SERVICE BULLETIN

Bulletin Number: SB1405
Date: 8/15/14

Product Affected: X-Treme, Prowler, and Fuzion mowers with serial number 58436 and above.

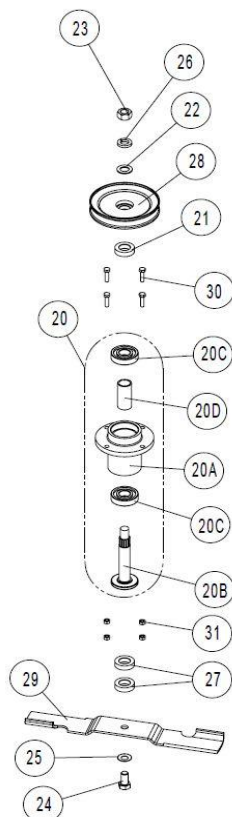
Situation: We had several field failures of the top spindle pulley. The description usually included that the pulley and or spindle shaft splines stripped out.

Solution: We found some parts variances that could cause the flat washer to contact the top of the spindle spline when the top nut was tighten. Should that occur then there would be insufficient clamp load on the top pulley. The insufficient clamp could allow the top pulley to wobble resulting in spindle shaft to pulley failure.

Parts Required: 823015 machined spacer reference Item 22 below
 One per spindle.

Warranty: Should a warrantable failure occur as described above the addition of the washer is warrantable and encouraged.
